# GLENVIEW PUBLIC SCHOOL - GYM ADDITION

CITY OF BURLINGTON  
BUILDING SERVICES  
REVIEWED  
FOR PERMIT ISSUANCE  
DATE July 10/2024  
PERMIT NUMBER 24 008616  
EXAM Ark

ISSUED FOR BUILDING PERMIT SUBMISSION

### ROOF FRAMING PLAN

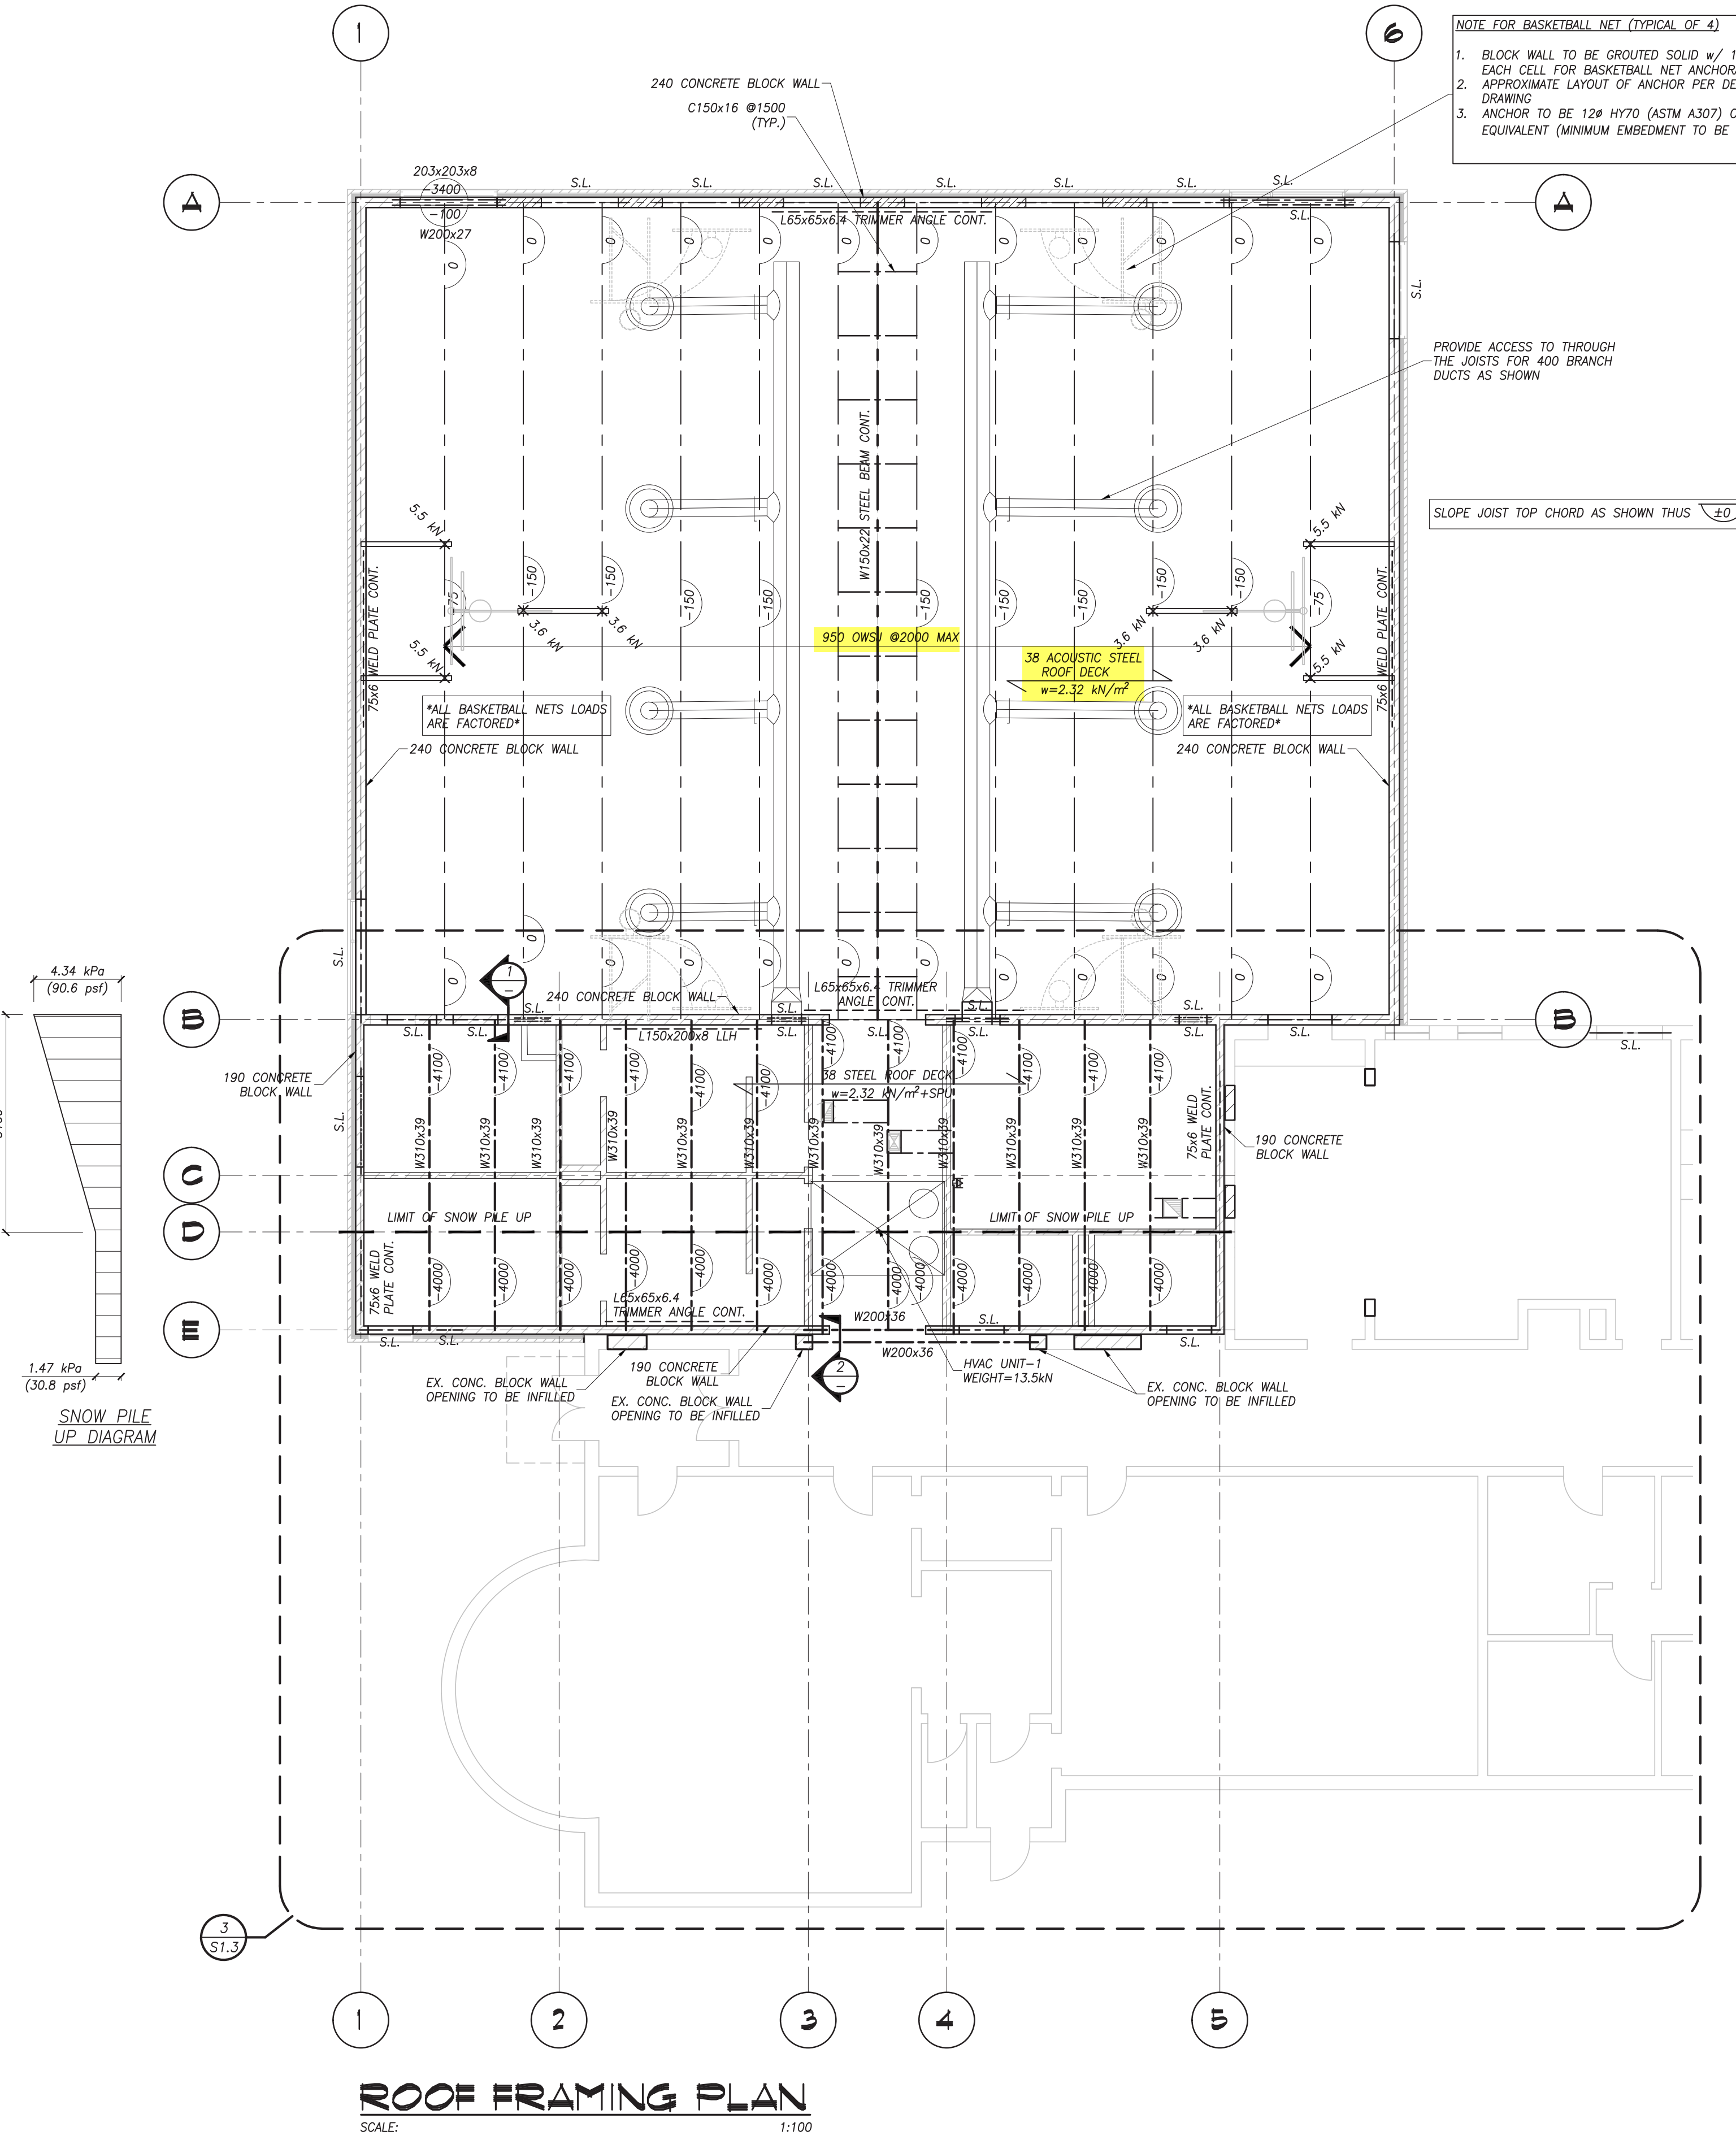
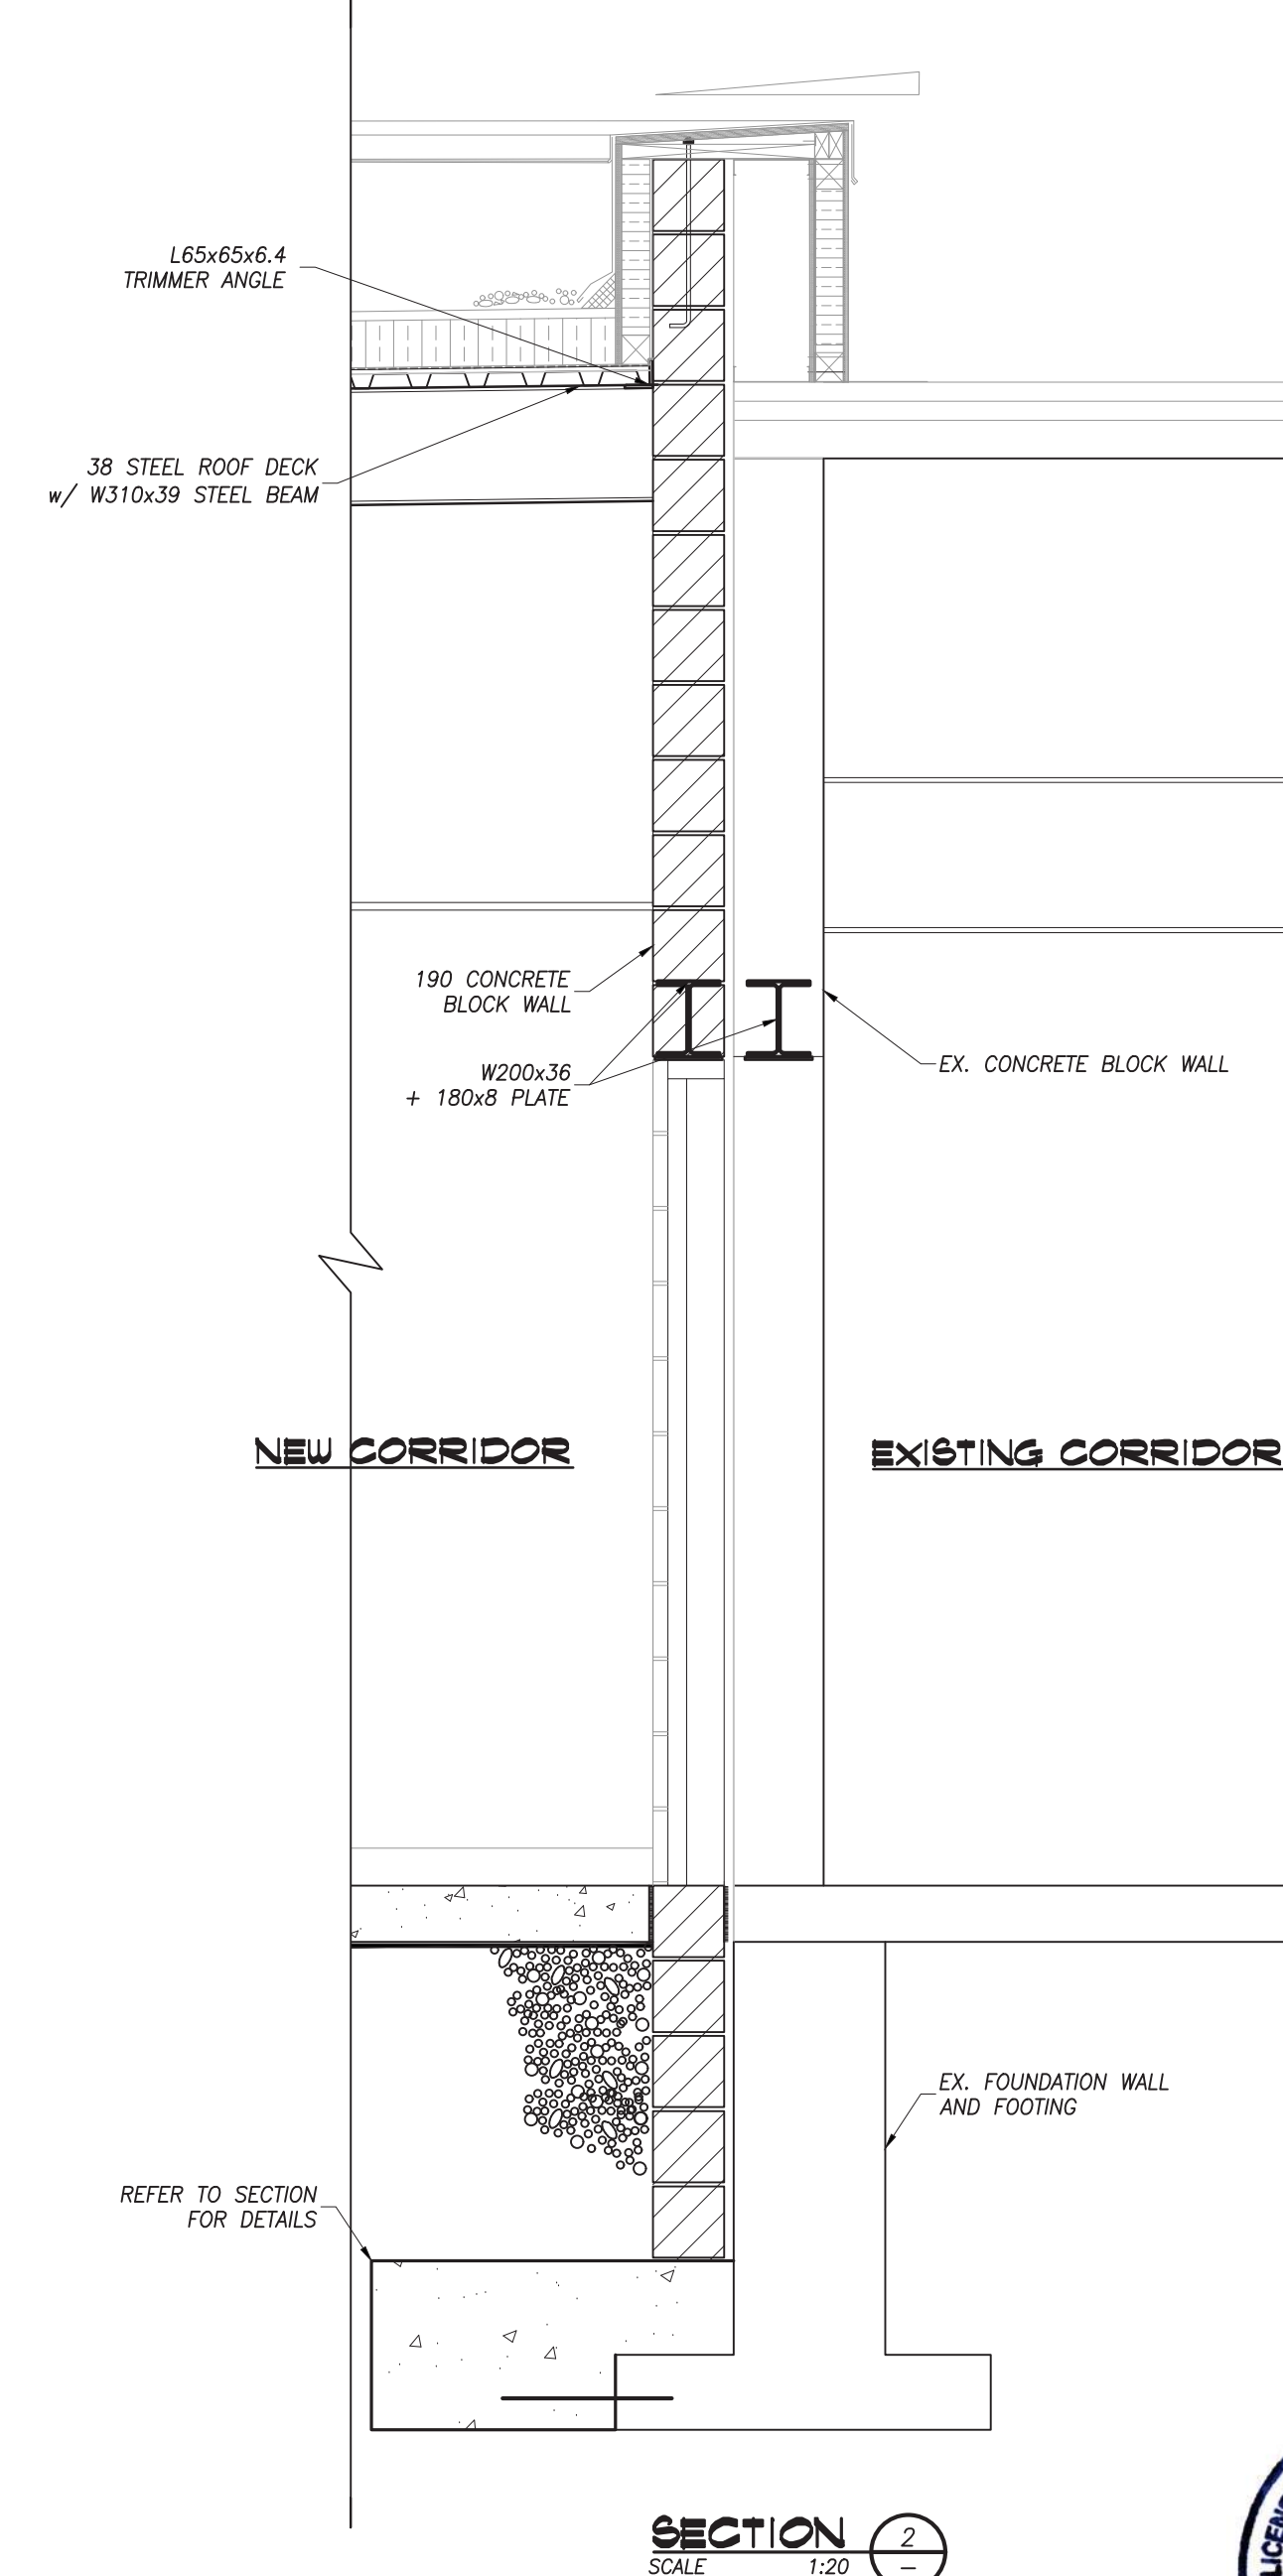
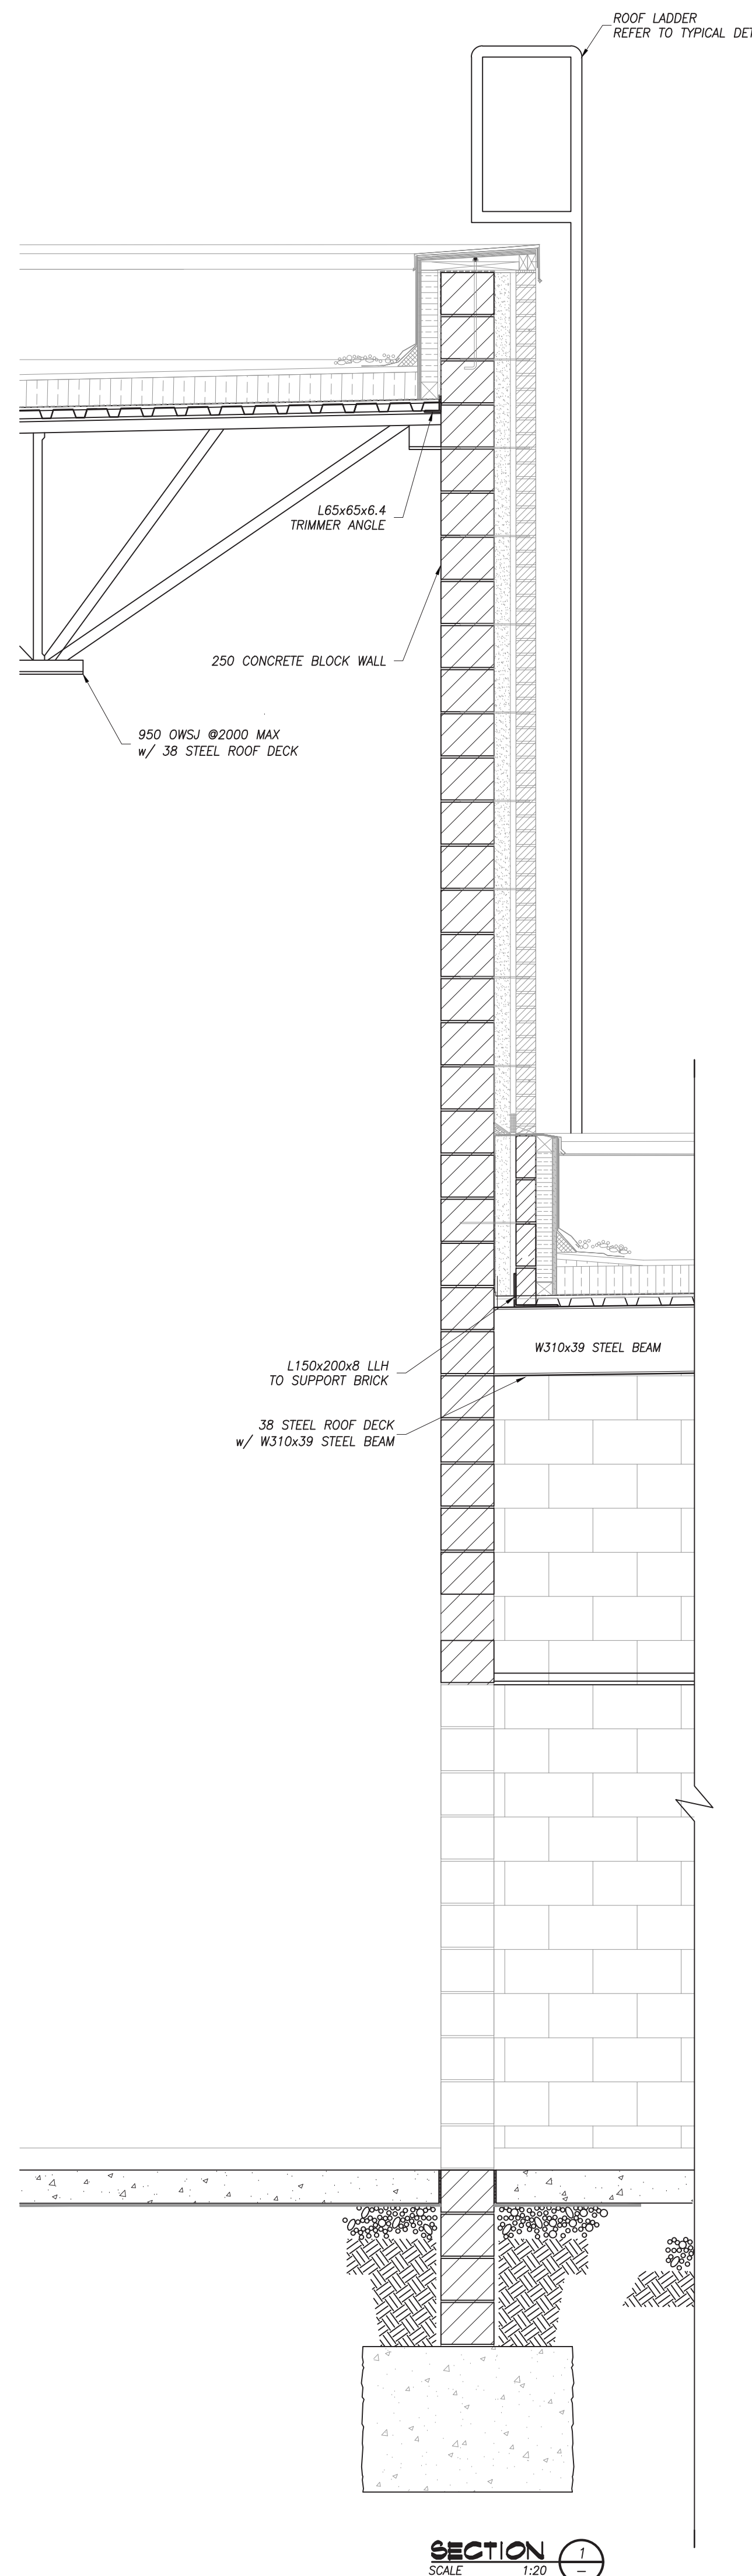
Provide safety cage around ladder as per Ministry of Labour requirement. Please see attached document/specifications.
